ADDENDUM NO. 4

February 10, 2023

SOLON ROBINSON ELEMENTARY SCHOOL ADDITIONS, RENOVATIONS, AND RELATED WORK Crown Point, IN 46307

A-102

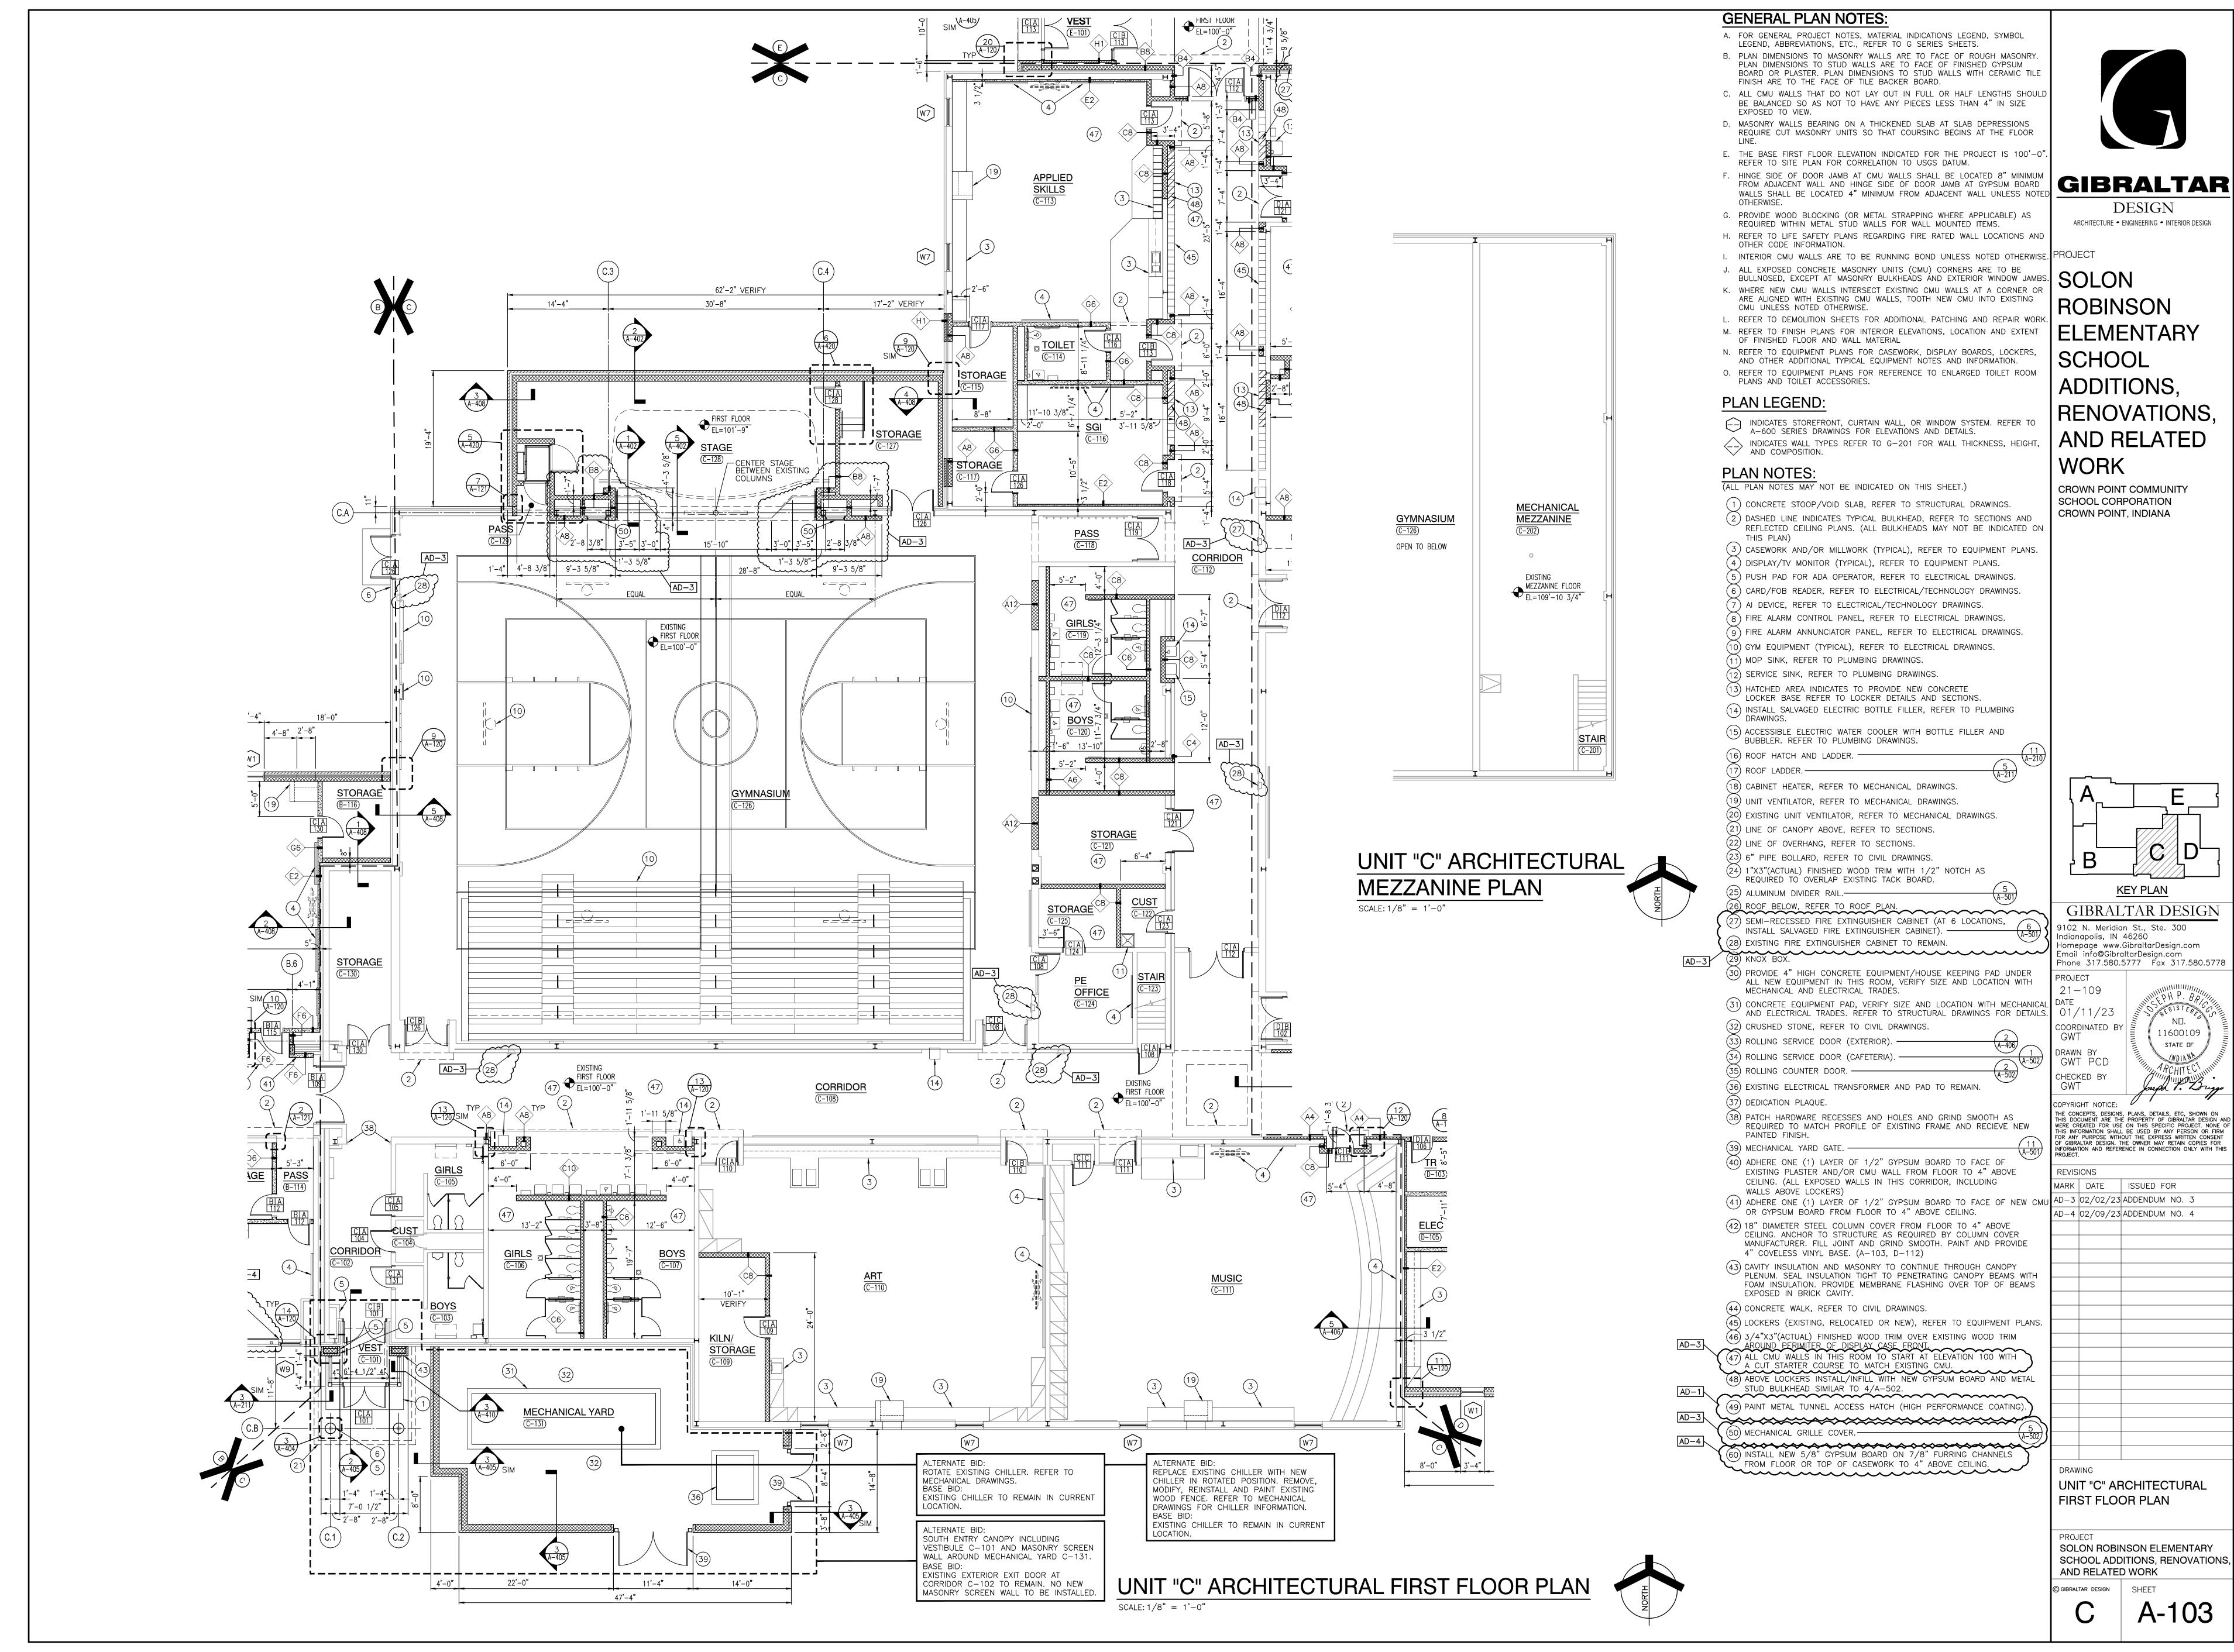
- A. Unit "A" Architectural First Floor Plan: Revise and add wall type tags and add wall section tags at existing EIFS locations. Add plan note regarding installation of gypsum board and metal furring.
- B. Unit "B" Architectural First Floor Plan: Revise and add wall type tags and add wall section tags at existing EIFS locations. Add plan note regarding installation of gypsum board and metal furring.
- C. Unit "C" Architectural First Floor Plan: Remove existing basketball goal support structure.
- D. Unit "E" Architectural First Floor Plan: Revise and add wall type tags and add wall section tags at existing EIFS locations.

Thursday, 2/9/2023 — 11:56 AM — LAST SAVED BY:PDEGROTH Y:\21—109 CROWN POINT CSC — ROBINSON ES IMPROVEMENTS\21—109 DRAWINGS\05 ARCH\A—120.DWG

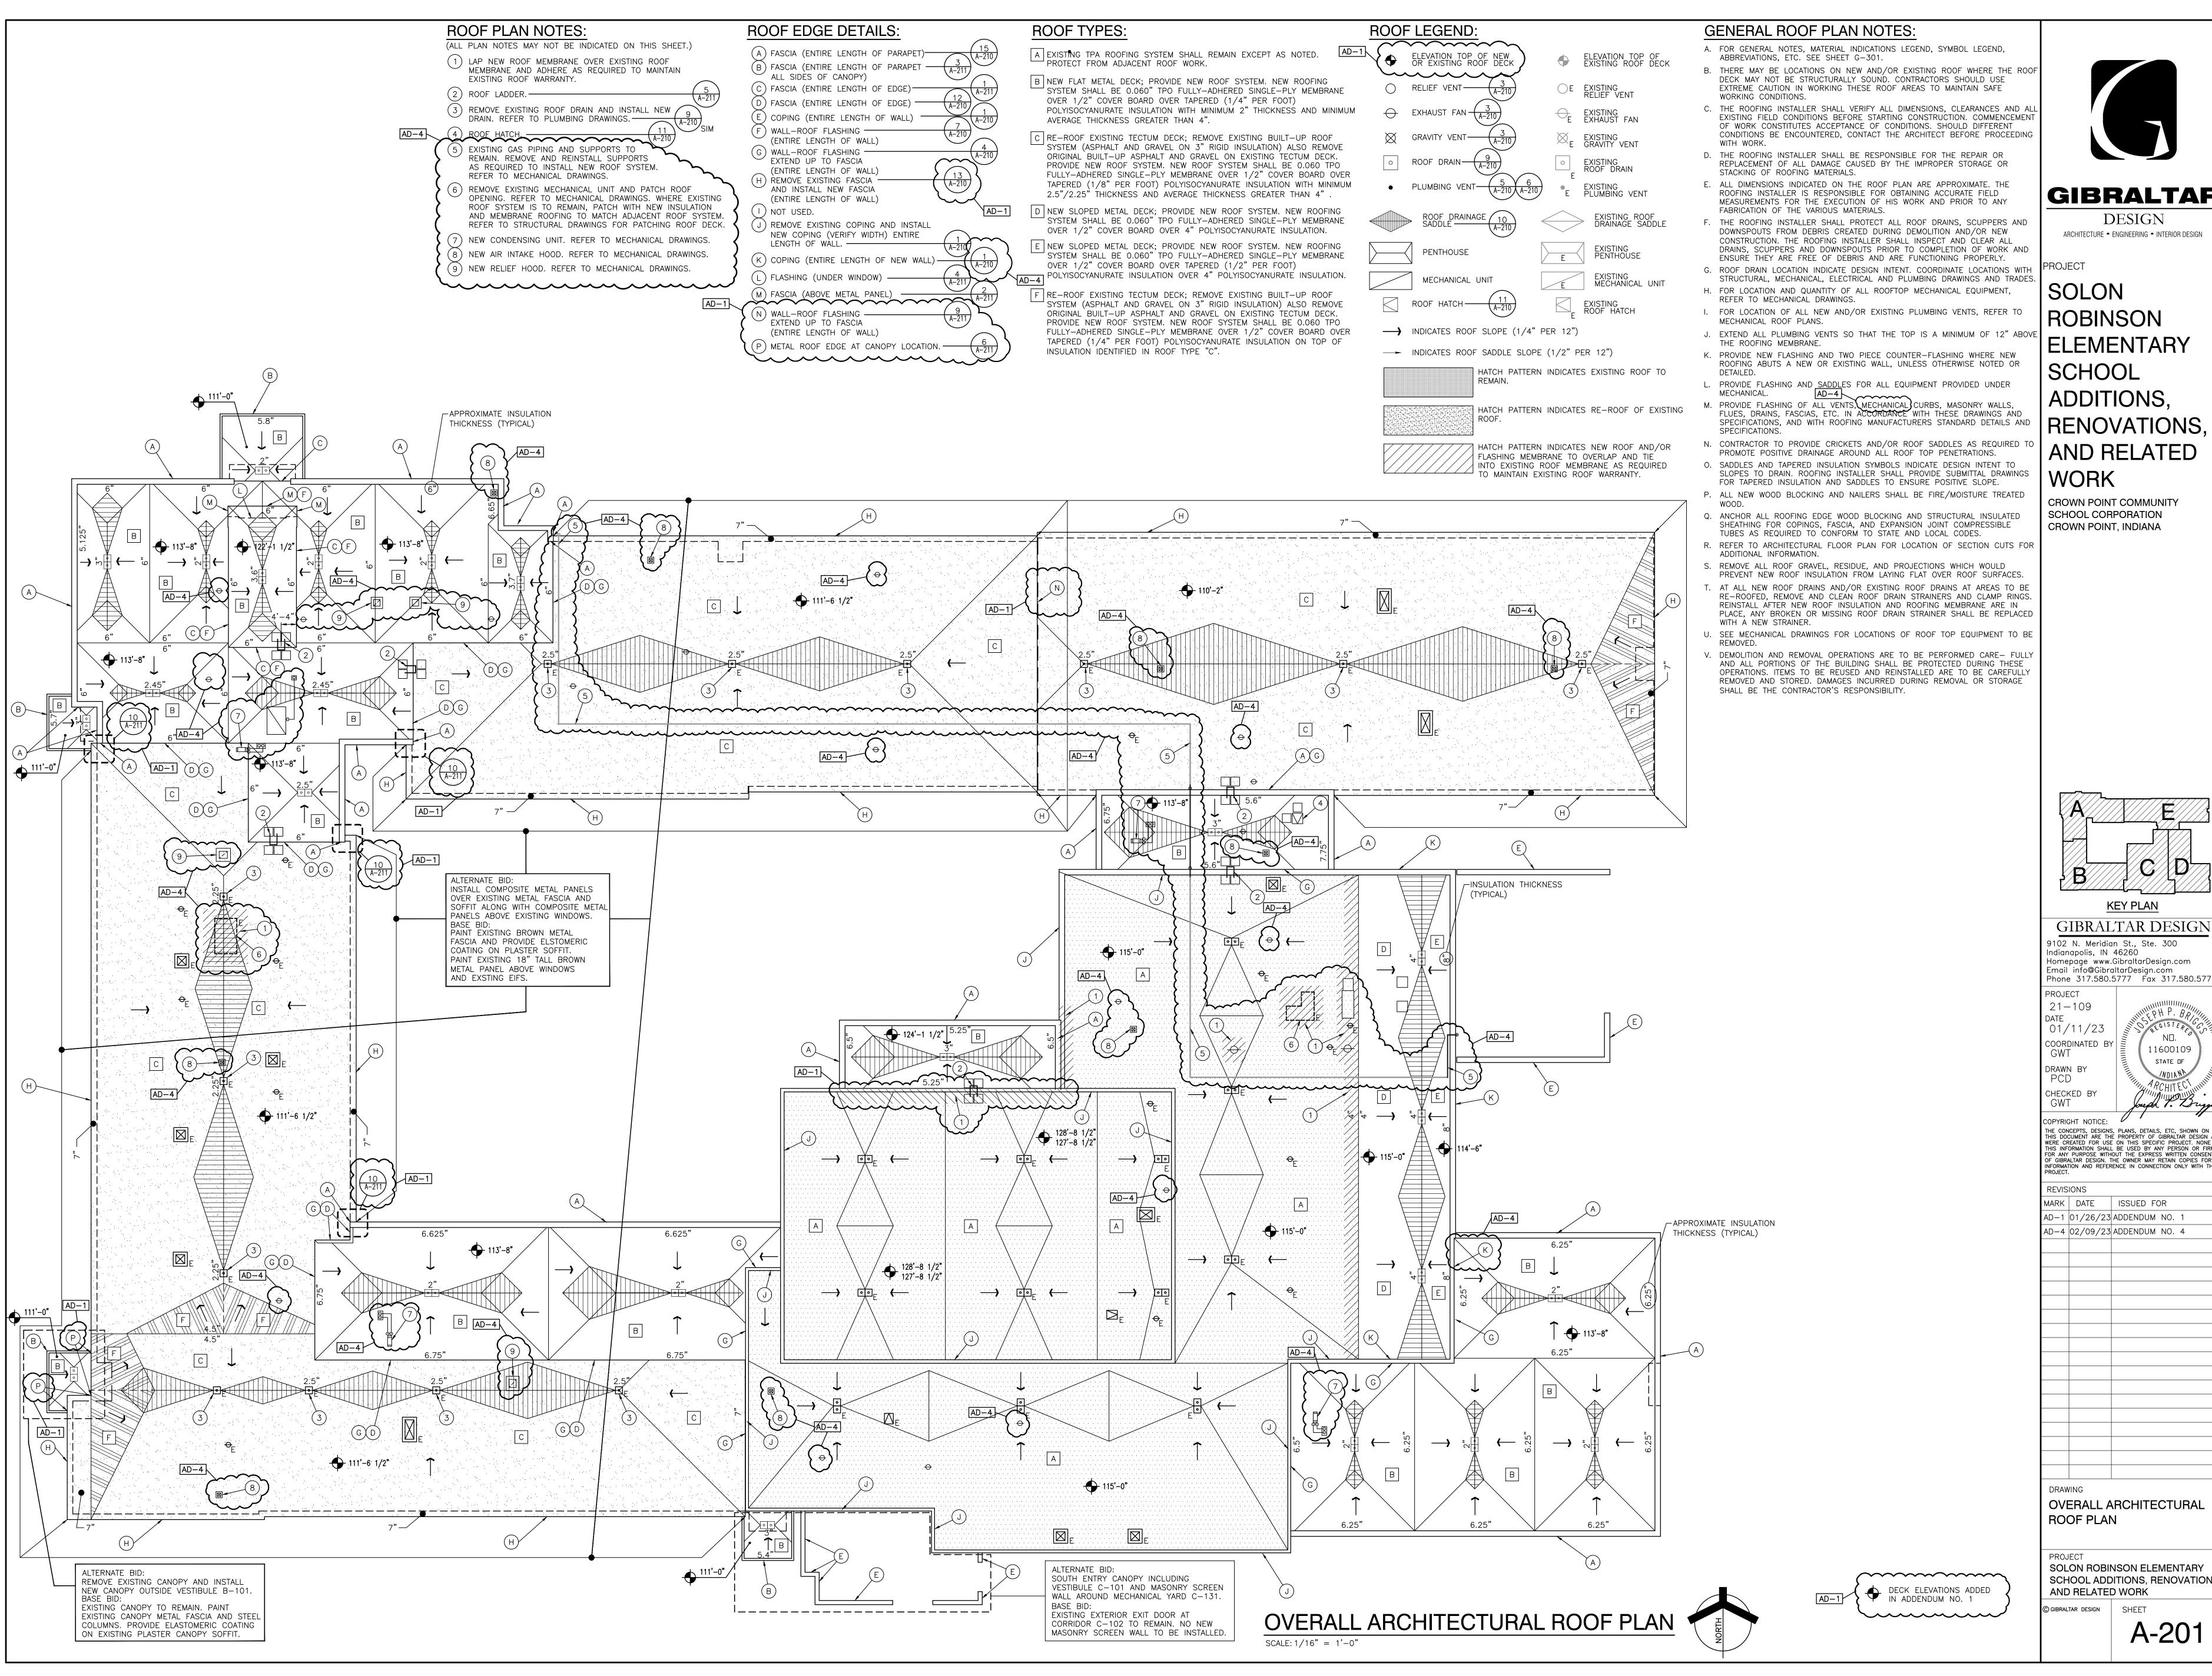
10. Sheet A-120

A. Revise Plan Detail 6.

A-201

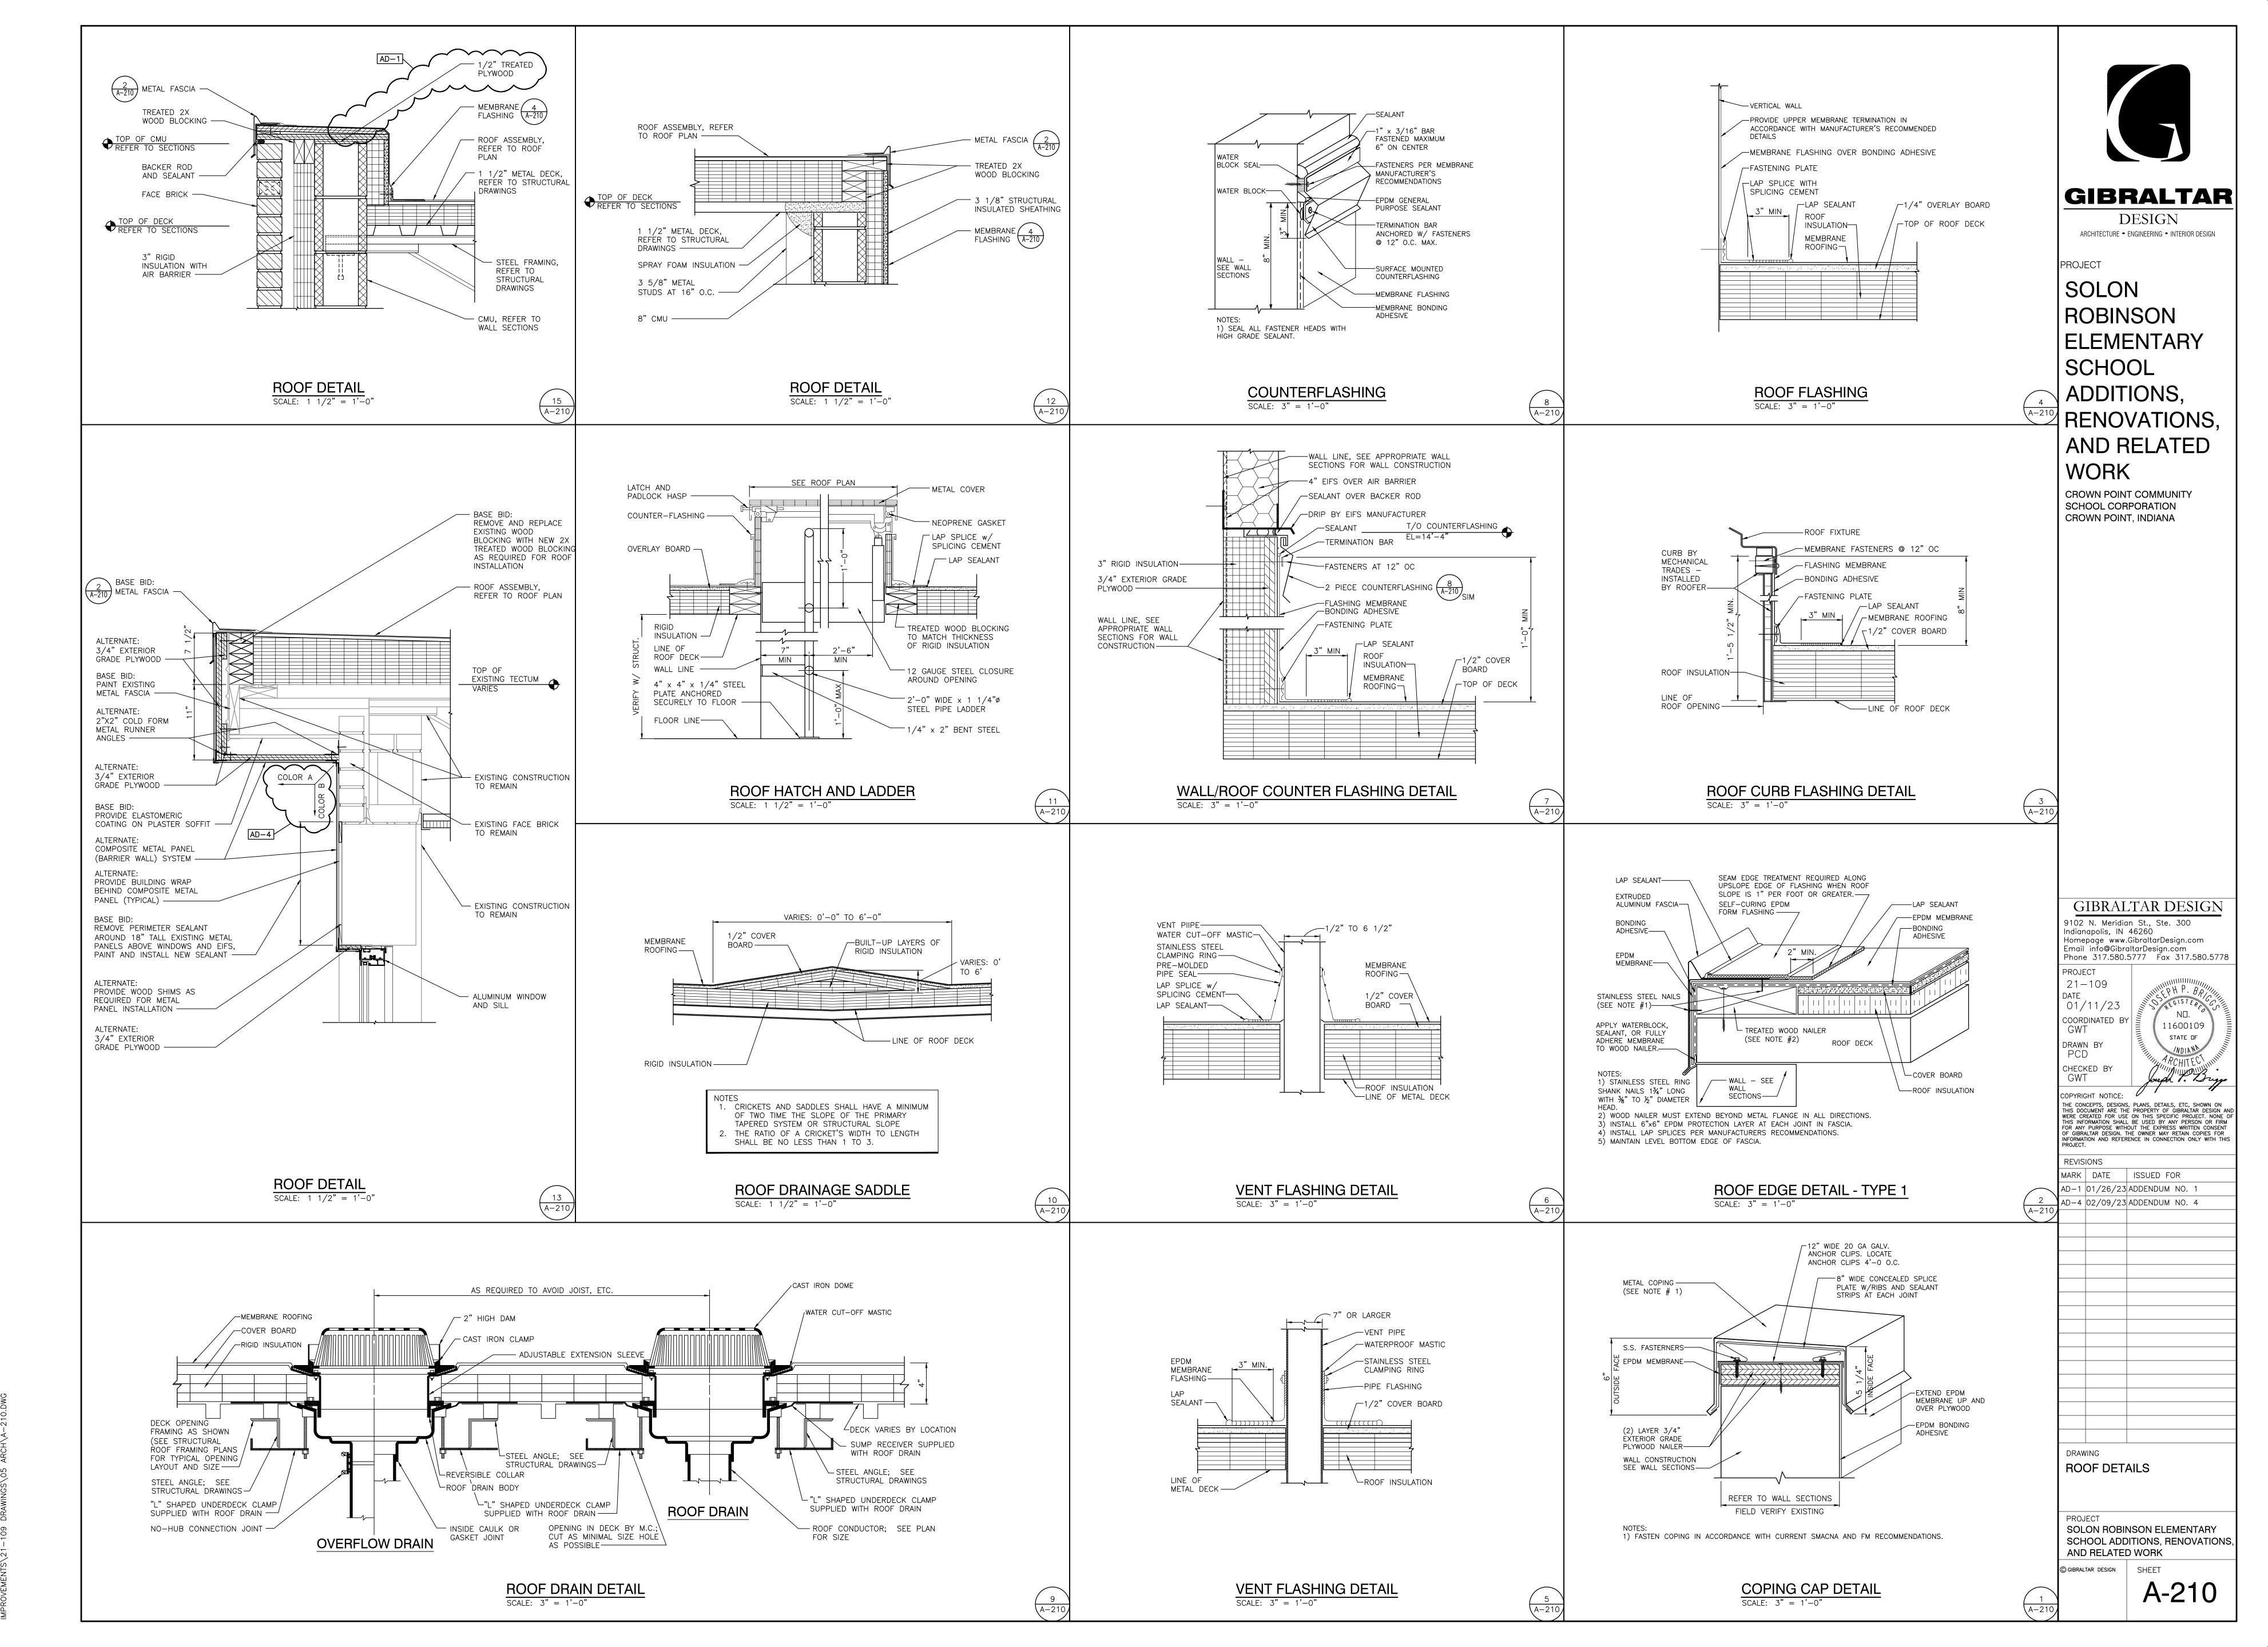
11. Sheet A-201

A. Overall Architectural Roof Plan: Revise notes as indicated on plan.
